# RENESAS TECHNICAL UPDATE

| Product Category   | MPU & MCU  |         | Document No.         | TN-16C-A230A/E                                  | Rev. | 1.00 |
| Title              | Errata to R32C/117 Group, R32C/118 Group, R32C/117A Group, R32C/118A Group, R32C/120 Group, R32C/121 Group, R32C/142 Group, R32C/145 Group, R32C/160 Group, R32C/161 Group User's Manuals Regarding CAN Module |         | Information Category | Technical Notification                          |      |      |

**Figure 25.34 Transition between CAN Operating Modes (i = 0, 1)**

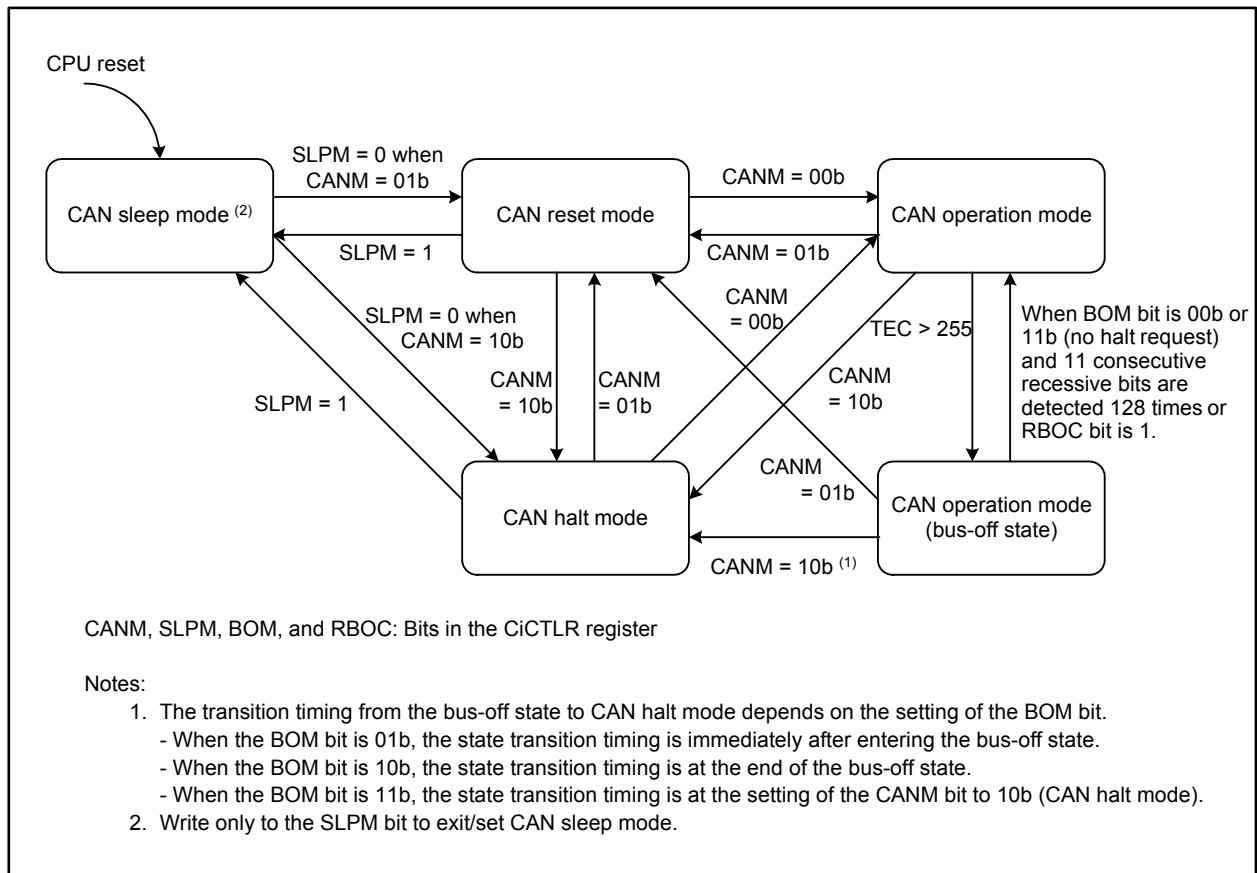
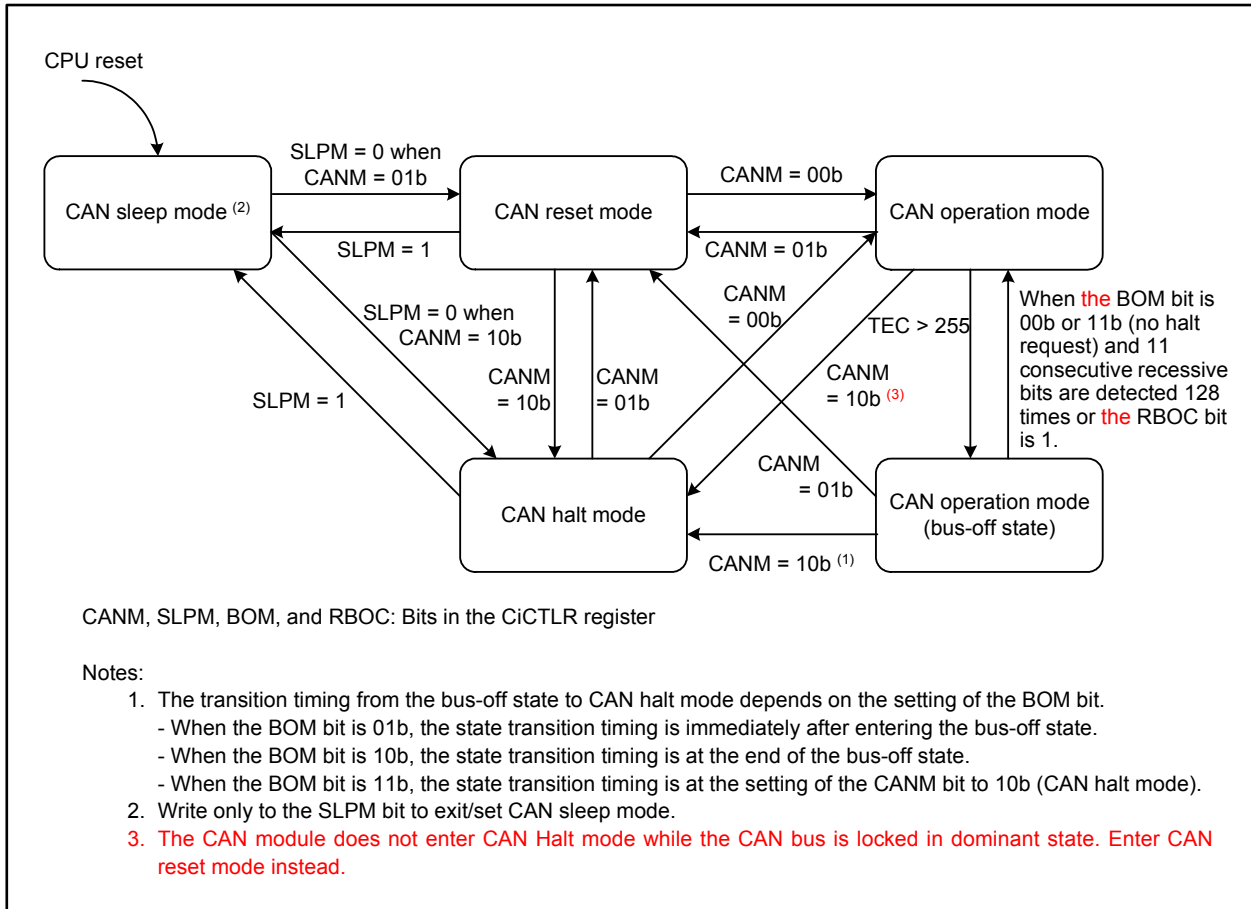
Note 3 is added to Figure 25.34 as follows:
